**CITY OF  
SAN LUIS OBISPO**

## **APPEAL FORM**

Project address: 2406 & 2414 JOHNSON AVE Application number: ARCH-0383-2021, SPEVACK

# APPEAL TO SAN LUIS OBISPO CITY PLANNING COMMISSION

## EXHIBIT B

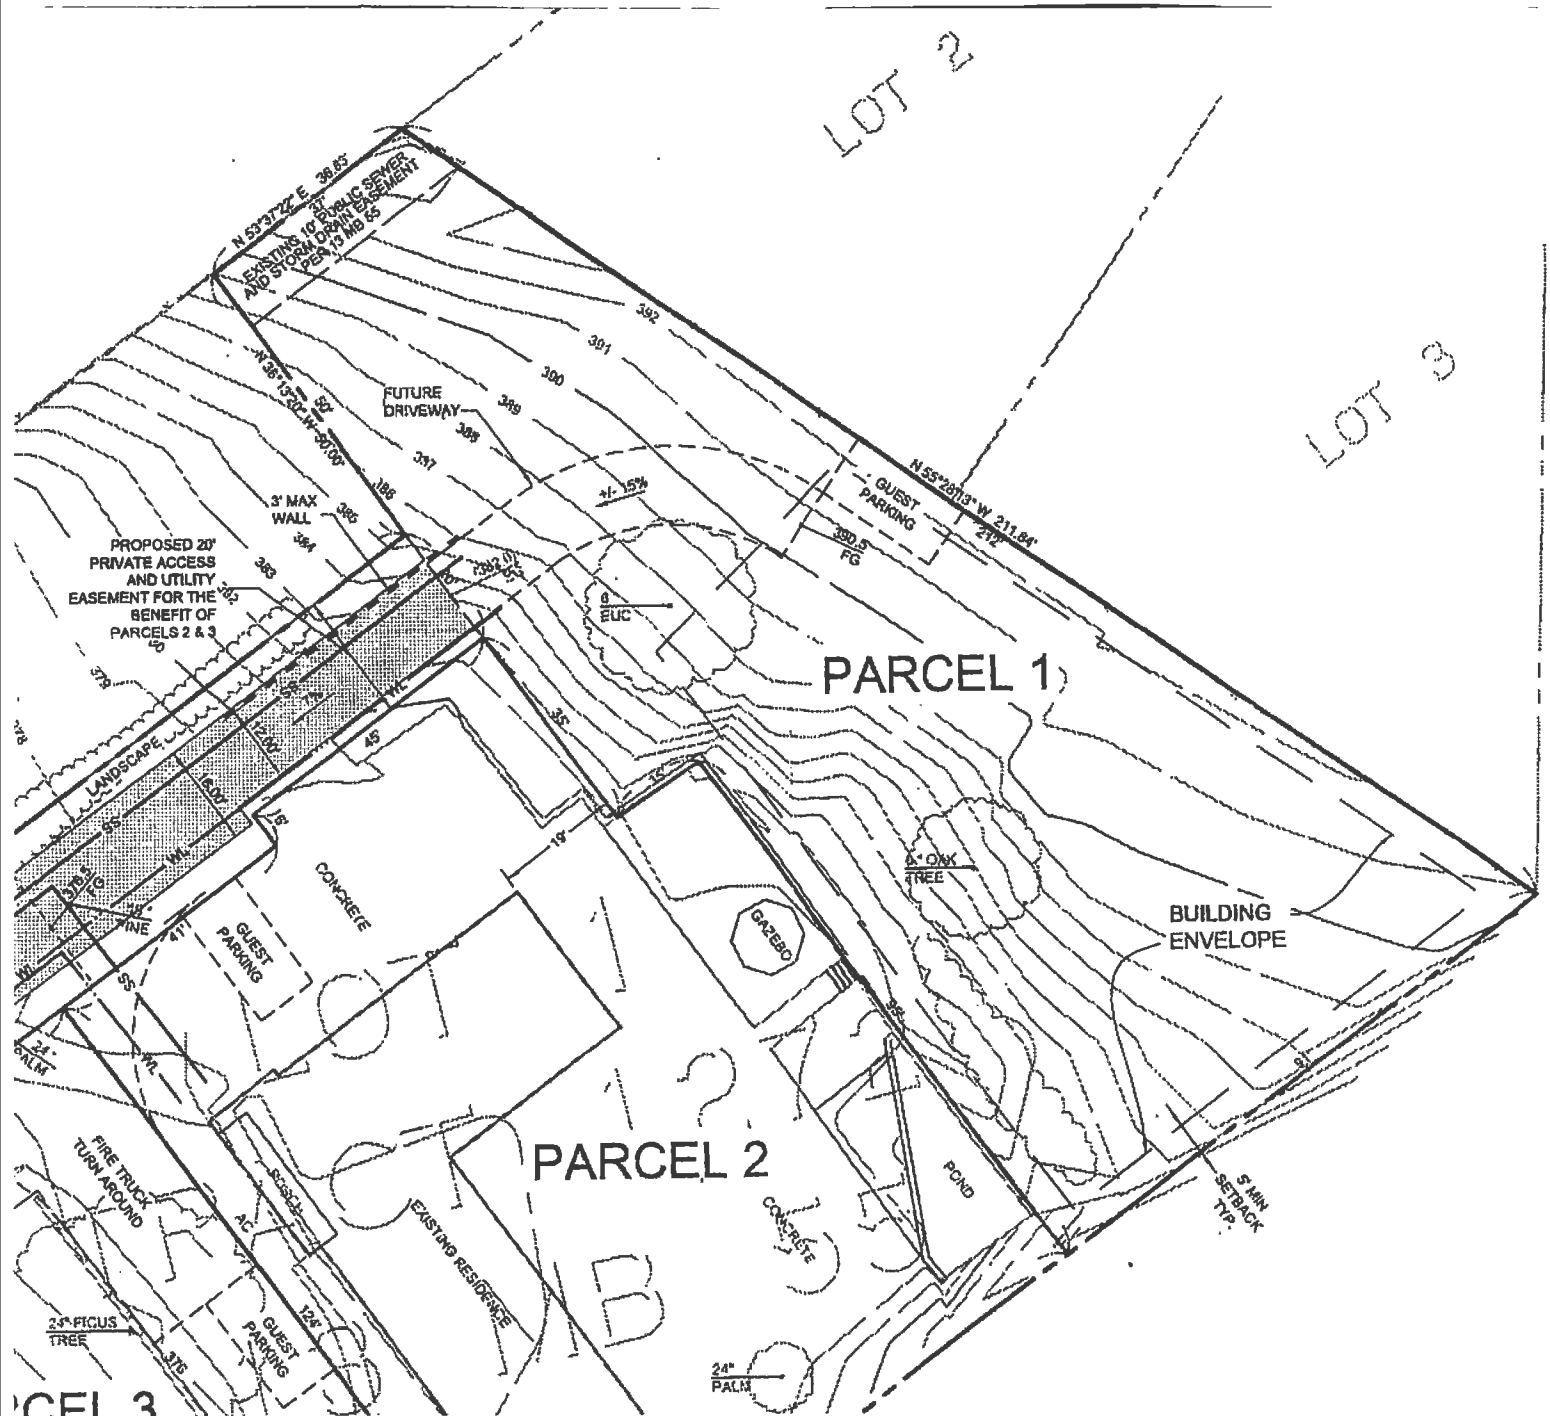
The building envelope that was submitted by the Applicant and his engineer from EDA clearly delineates a building envelope on the Tentative Map on both Parcels #1 & #3. This was indeed modified by the Planning Commission, requiring the rear yard envelope to be reduced to 10-feet (shrinking the building envelope an additional five feet). Please refer to attached Exhibit of the Tentative Map delineating these envelopes (Exhibits A, B & C).
